**From:** Peter Bradfield <Peter.Bradfield@suffolk.gov.uk>  
**Sent:** 09 December 2024 19:40  
**To:** Mills, Penelope; Waugh, Charlotte  
**Subject:** DC/24/1452/RM | Reserved matters application - a. submission of details under DC/15/2151/OUT for access, appearance, landscaping, layout, and scale of the local community centre (Class F2(b)) within Parcel D1 pursuant to outline permission DC/15/2151/OUT,

Thank you for your consultation on this Reserved Matters application DC/24/1452/RM for the Zone D1 land in Haverhill. Suffolk County Council, as the Highway Authority, offer the following comments.

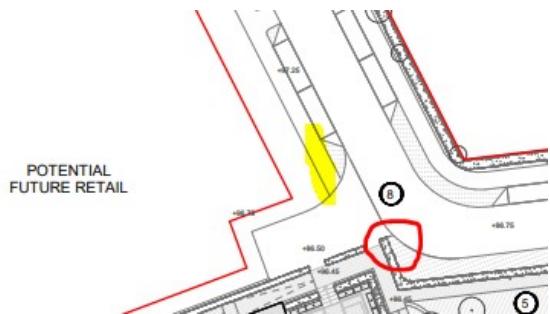
The Highway Authority notes that the development under consideration does not include the parcel of blue line land in the eastern section that is allocated to potential healthcare use or the parcel of blue line land in the northern section that is allocated to potential retail use.

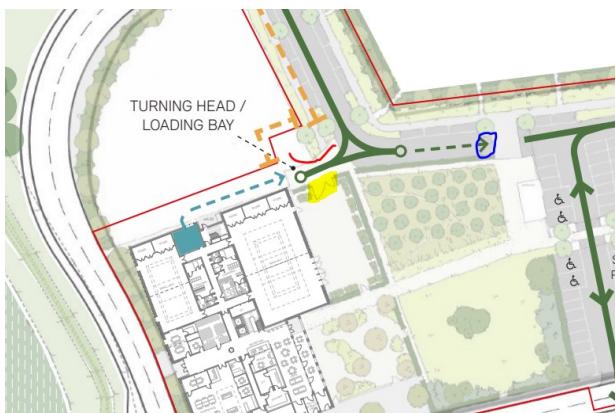
The snip below is taken from the Proposed Site Block Plan Drawing No. DR-A-300002 C1. The yellow highlighted route is the southern end of a footway which runs from Gurteen Avenue but the continuation on the southern side is not directly opposite which is unfortunate. This will be an important walking and wheeling route towards the development, and it would be desirable to ensure the route follows the desire line as closely as possible and doesn't introduce any pinch points, as may be the case with the continuation footway where there appears to be a narrowing between vegetation.

This part of the site will provide a vehicle turning head that will be used by refuse collection vehicles. The red circle in the snip below shows that there will not be a radius on the southern kerb line. Because this section of road is to be used for vehicle turning, this layout may be inconvenient and lead to kerb damage.
